Bid 26-27

Robert Crown Storage Room

ADDENDUM No. 1

This addendum forms part of the Request for Proposal Documents for Proposal #26-27 and modifies these documents. This addendum consists of the following:

5 :: ENLARGED PLAN @ TYPICAL STORAGE BAY
1 scale: 1/4" = 1'-0"

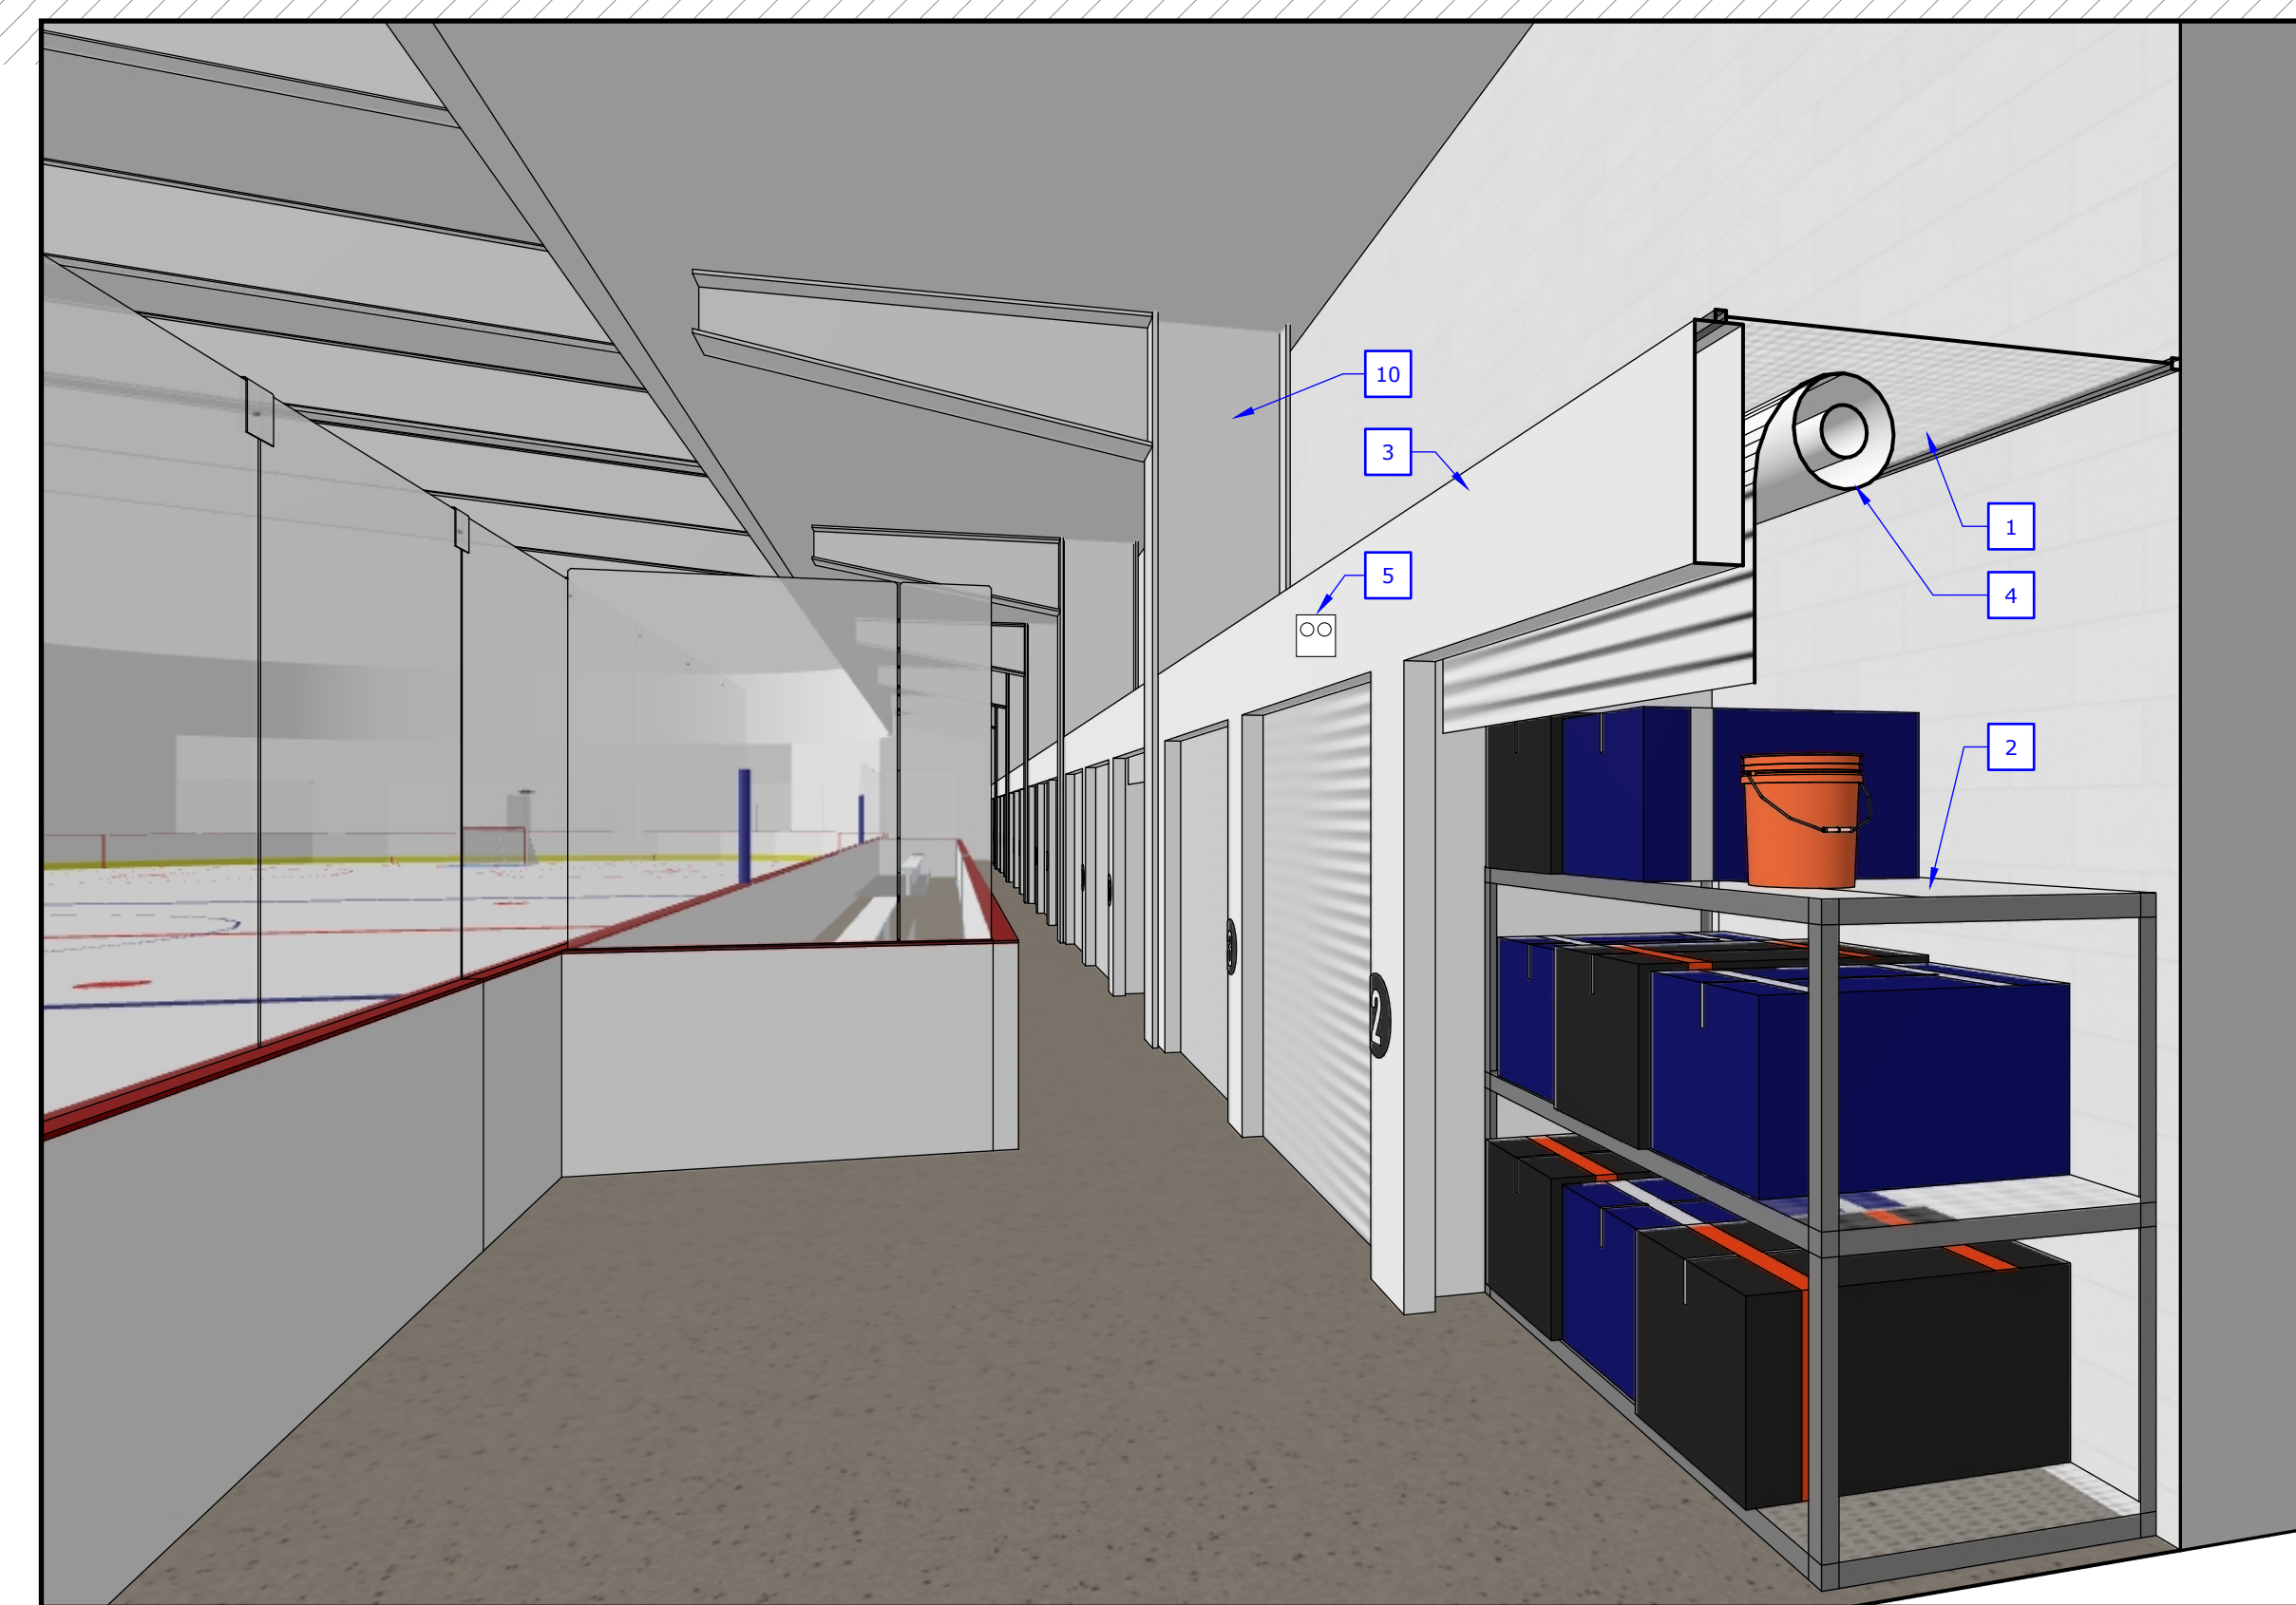
1. Updated Drawing set (Sheet A1) showing enlarged plan of room where walk-in refrigerator is to be located, clarifying that a new door is to be added in the existing CMU wall.
2. Electrical Plan of existing building provided to show location of nearest electrical panels, as it relates to providing power to the walk-in refrigerator.
3. Plumbing Plan of existing building provided to show location of nearest sanitary pipe, as it relates to providing drainage for condensate from walk-in refrigerator.
4. Site Plan of existing building provided to show location of construction dumpsters and material storage/staging.
5. Pre-bid meeting sign-in sheet

Site Dimension Plan - West

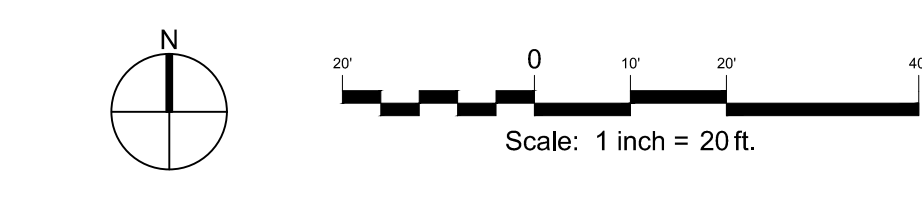
- Q. Where will the construction dumpster and material storage be located?
A. In the parking lot behind the north side of the building (see attached Site Plan)
